2015SYE158 – 34-38 Railway Crescent, Jannali

DA15/1345

ASSESSMENT REPORT APPENDICES

DEFERRED COMMENCEMENT CONSENT

CLIENT		White & Partners	
PROJECT		PROPOSED MIXED-USE BUILDING	
34-38 RAILWAY CRESCENT		JANNALI	
DRAWING		PLAN	
LEVEL 2 (EAST)		A(E)203-B	
1523	DA	1:100@A1	MC

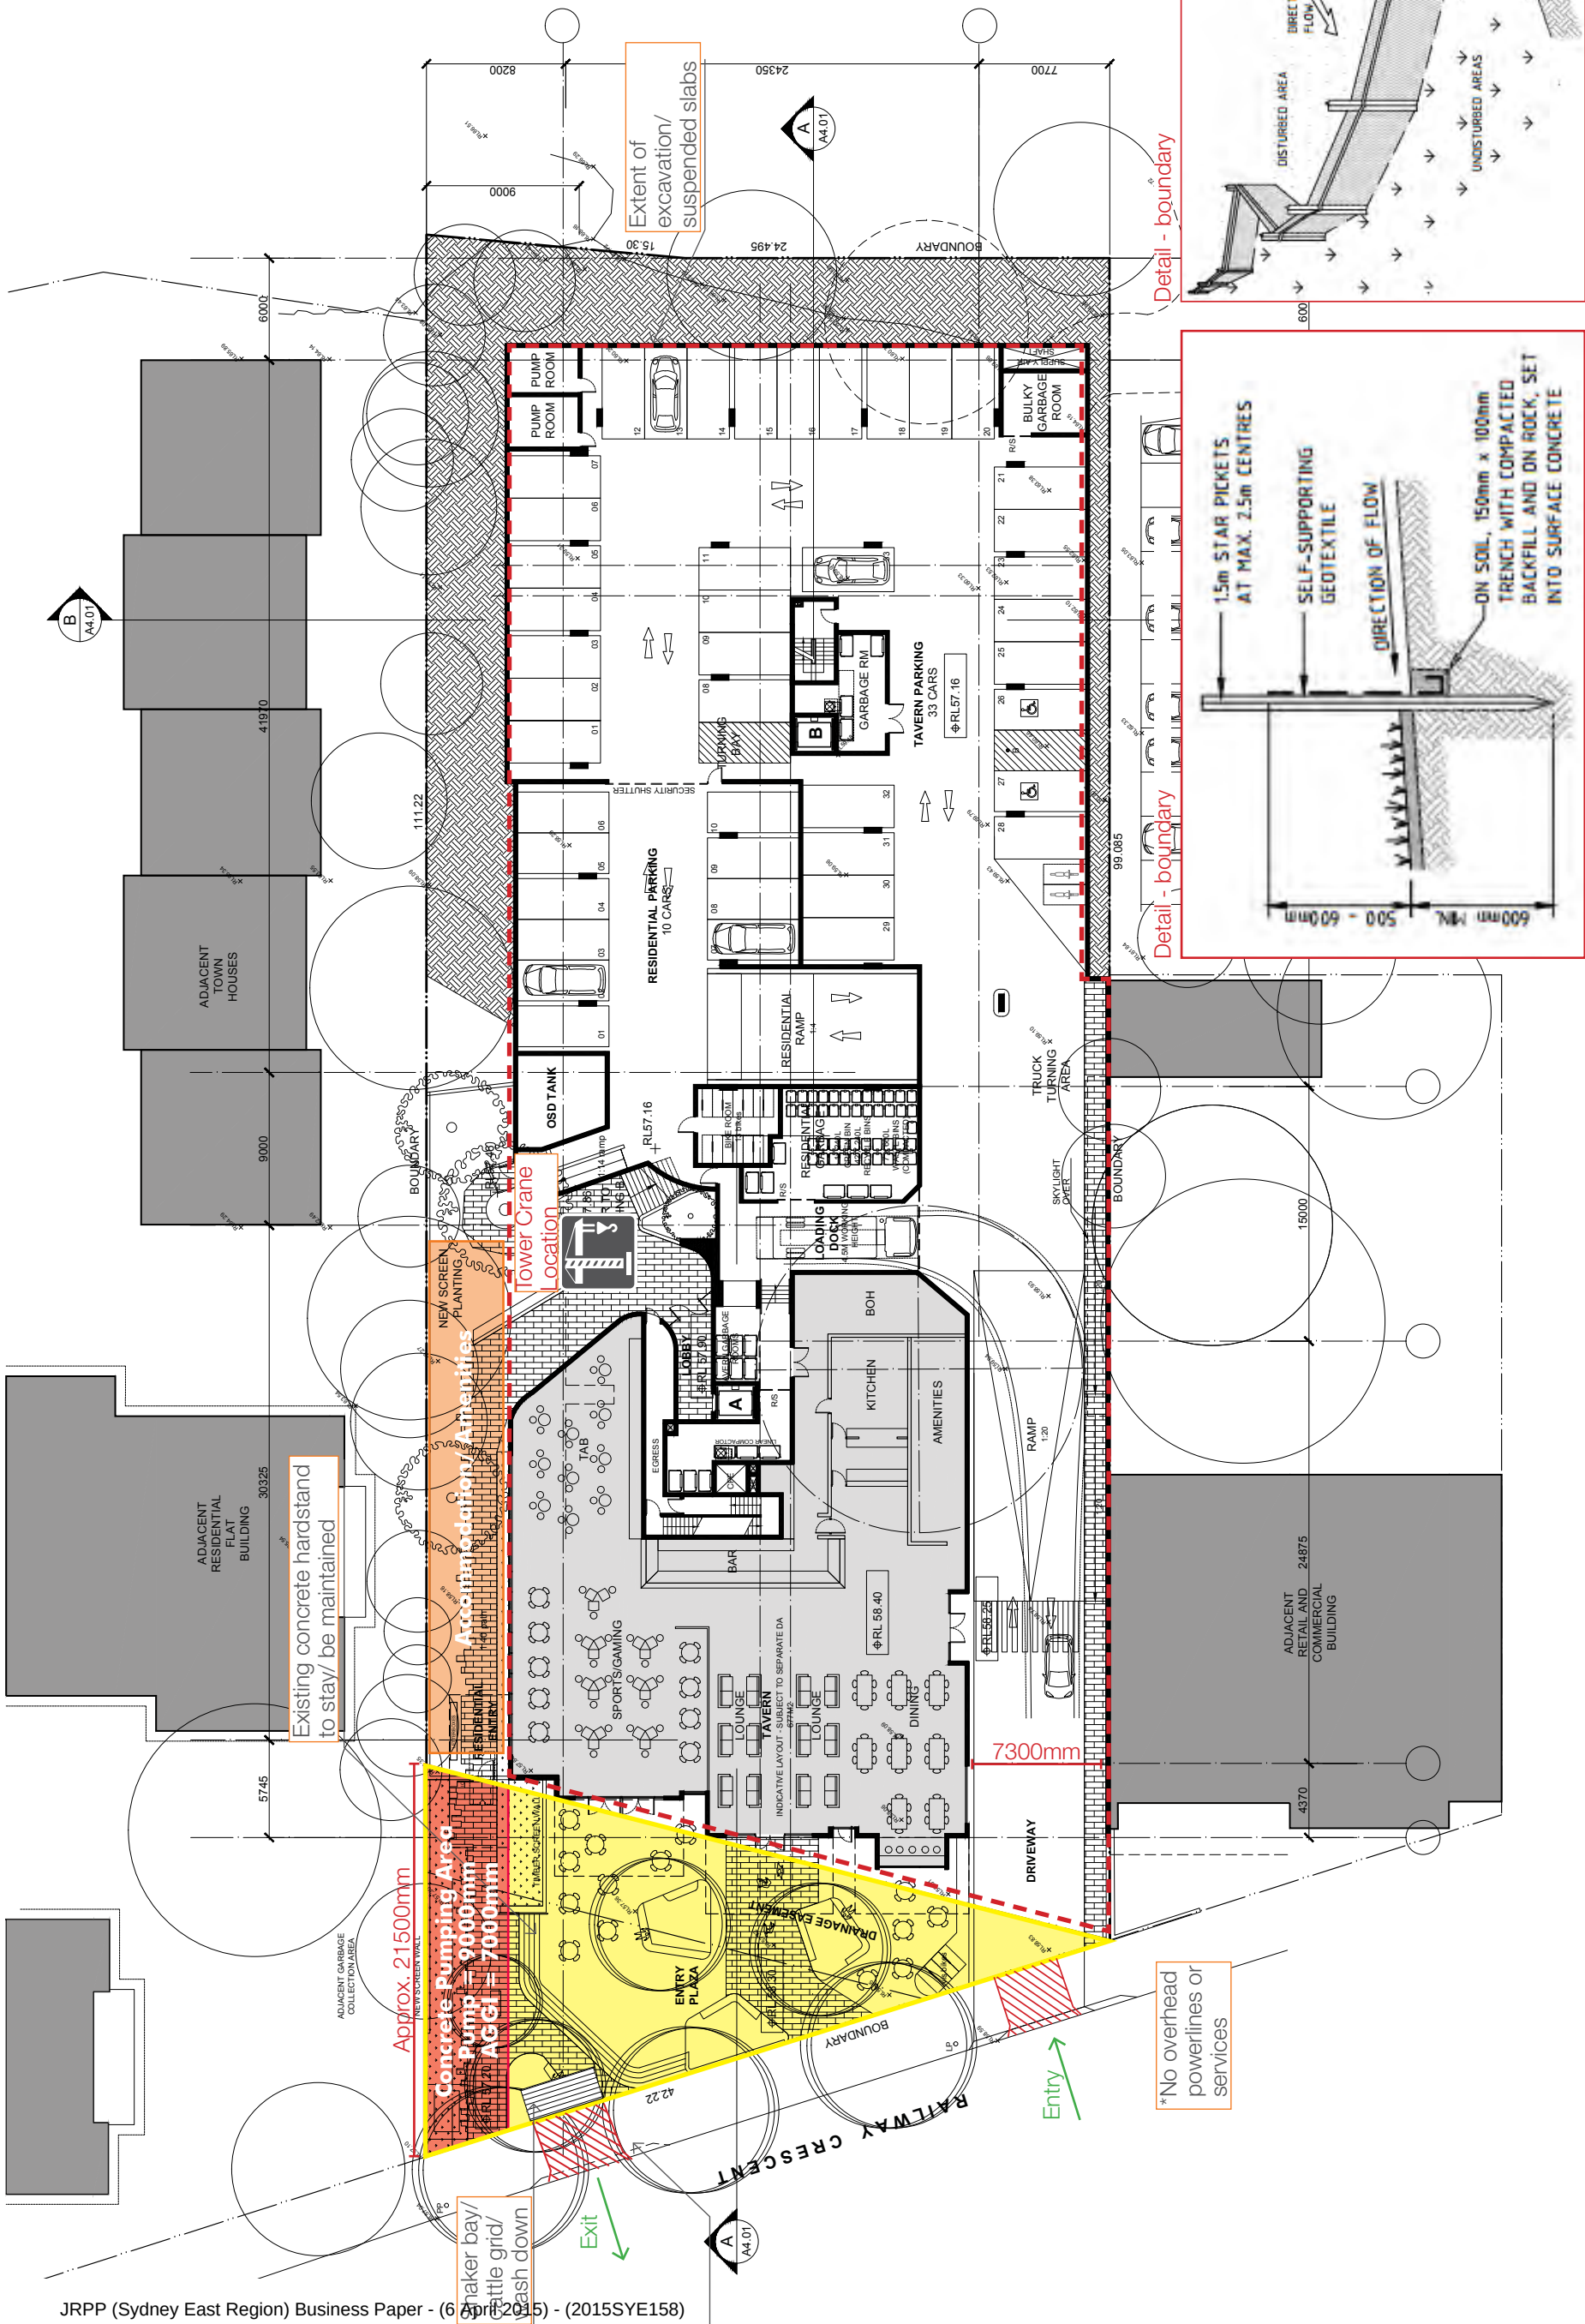
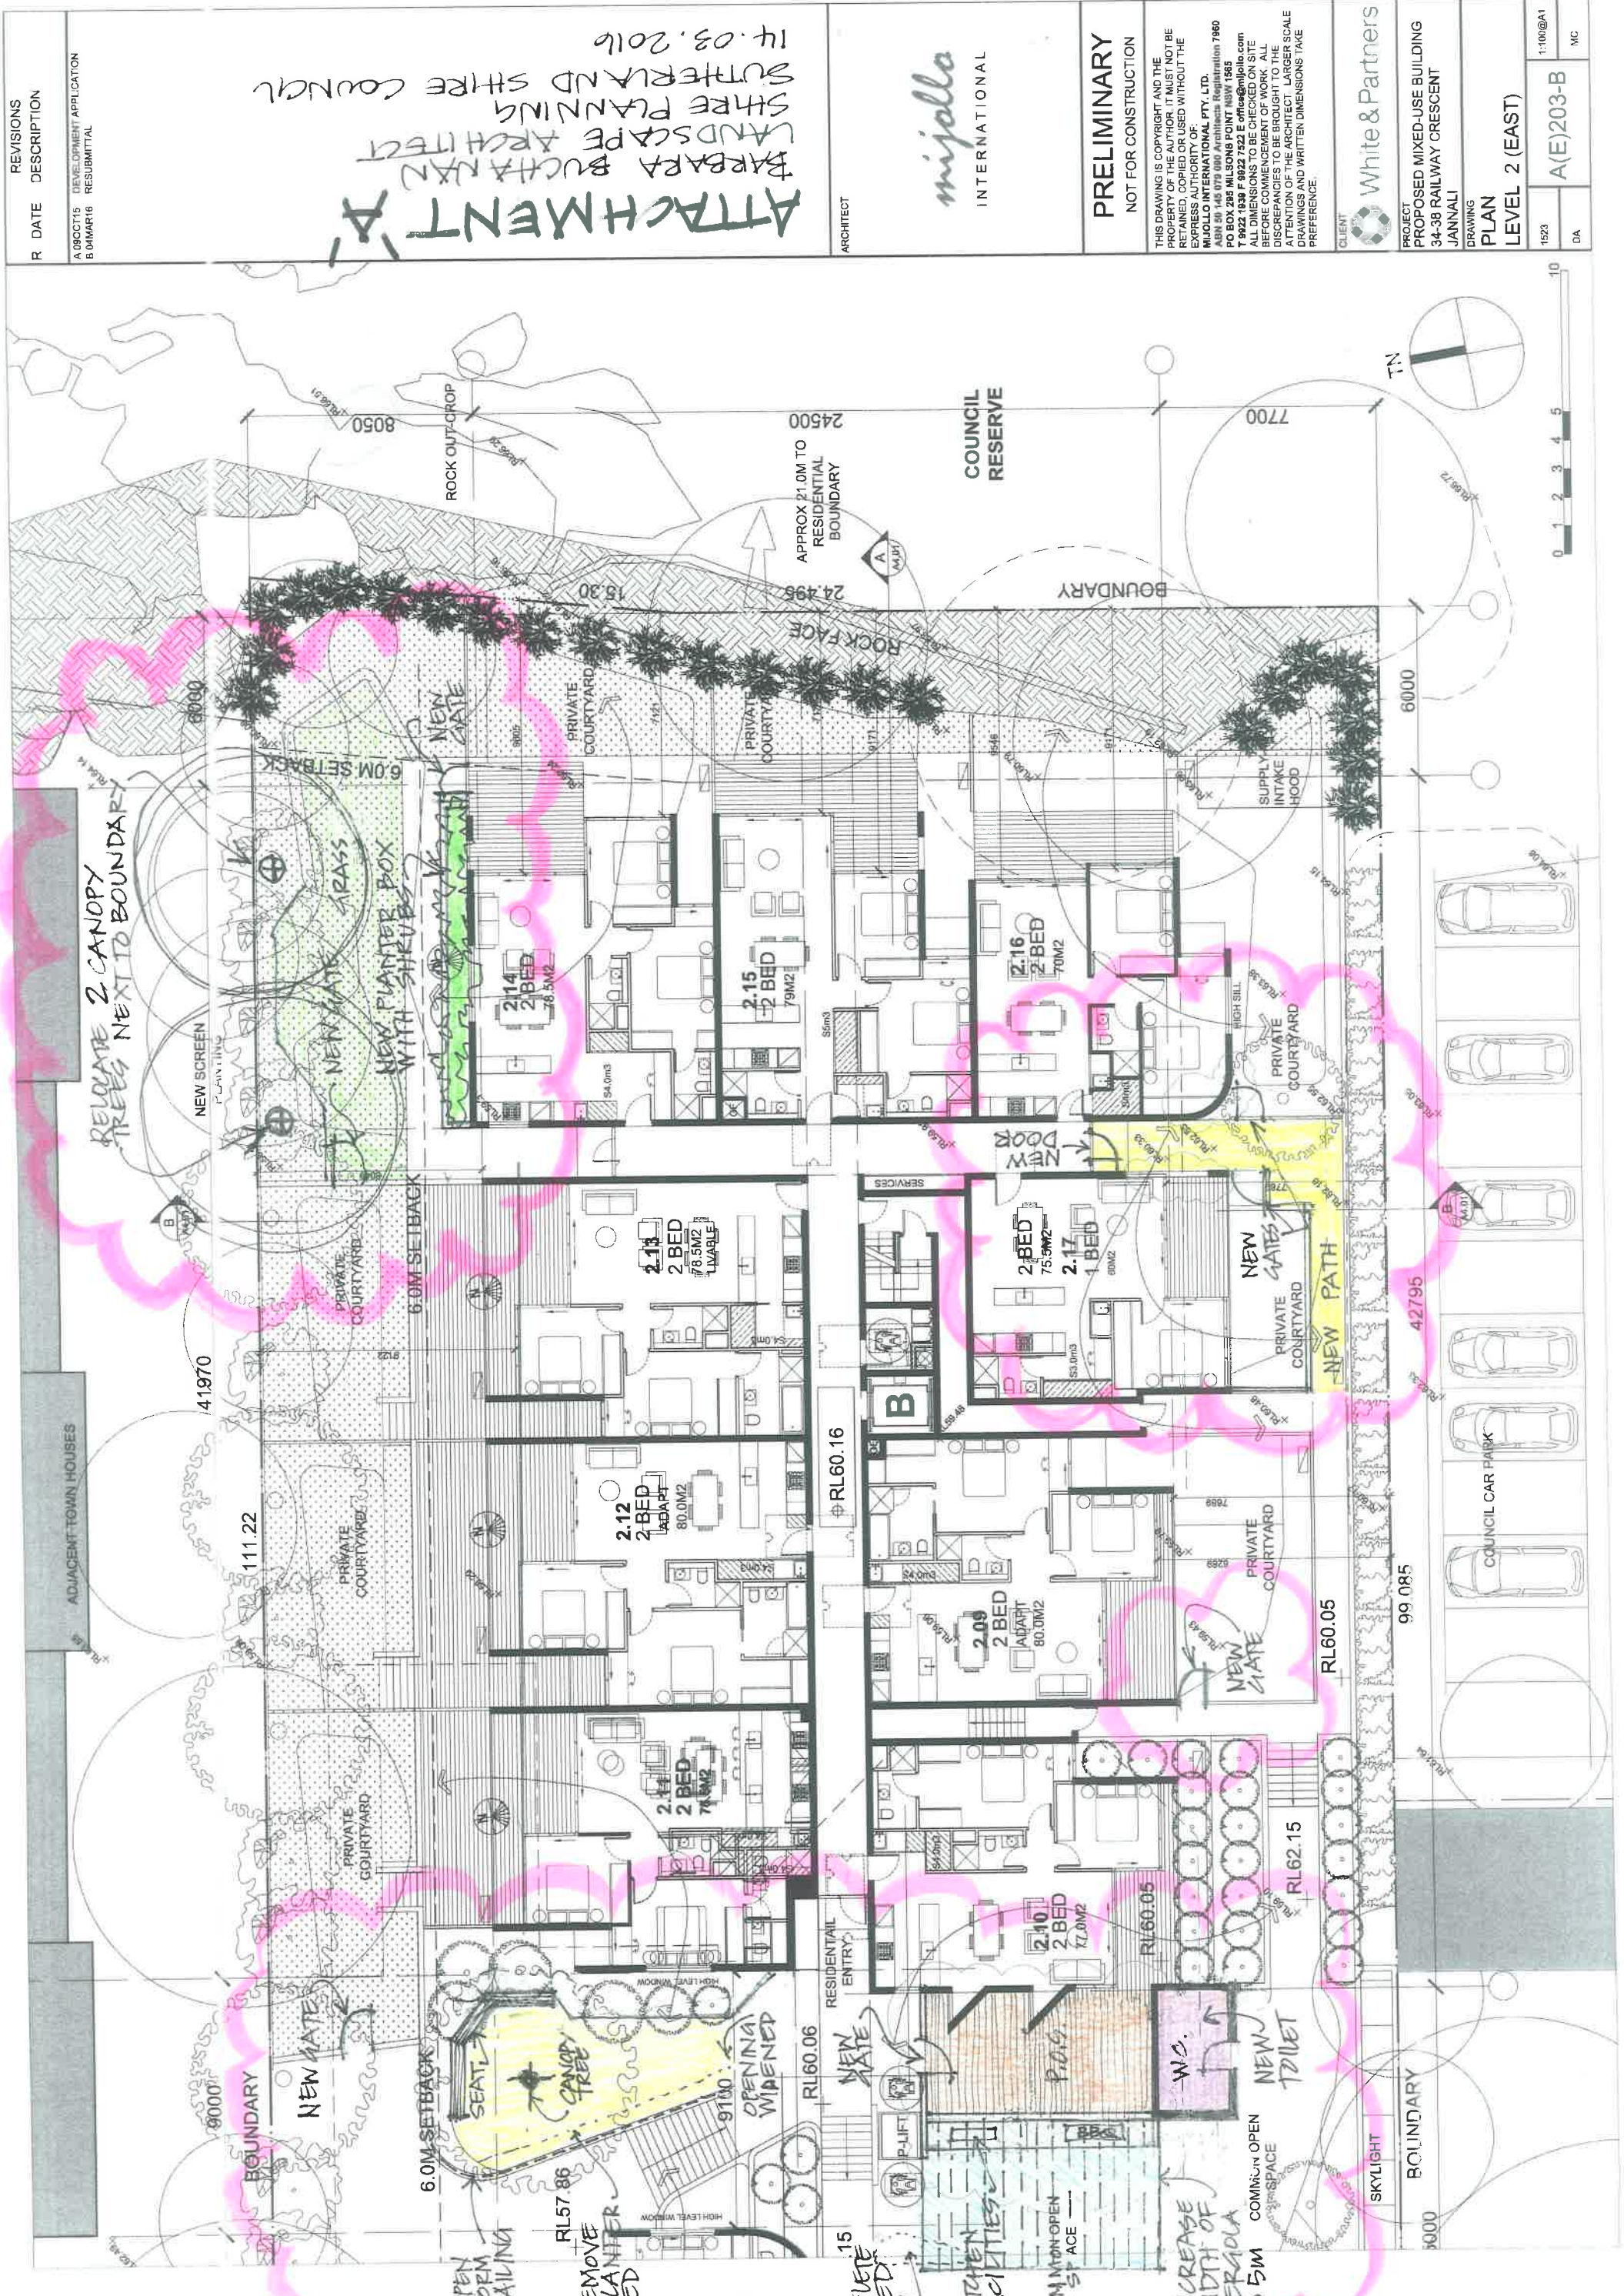
- i) The landscape plan shall be updated as per the Architectural Plan labeled A(E) 203-B "Attachment A" amended by Sutherland Shire Council on 14.03.2016, and detailed below:

- In the COS in the NE corner of the site reduce the area of paving and planting and enlarge the area of grass to provide a more open, visually accessible space with better surveillance. Relocate the large indigenous trees 3m from the line of the basement.

- To Level 1 of Building B, reduce the Private Open Space (POS) of Unit 2.17 and provide a shared pathway between the corridor on the eastern side of Unit 2.17 and the path on the southern side of the courtyard of Unit 2.09.

- Provide rear gates between the private courtyards of Units 2.09, 2.10, 2.11, 2.13, 2.14, 2.16 and 2.17 and the adjoining shared pathways or Common Open Space (COS).

- In the COS between Units 2.01 and 2.11, replace the planter box on the western side of the breakoff space with paving to improve surveillance to and from this area.

- In the COS between Units 2.02, 2.03 and 2.10 delete the breakoff space on the western side of Unit 2.10 and reconfigure the area. Provide a larger BBQ area, some all-weather protection and a toilet, with a small area of POS on the western side of Unit 2.10.
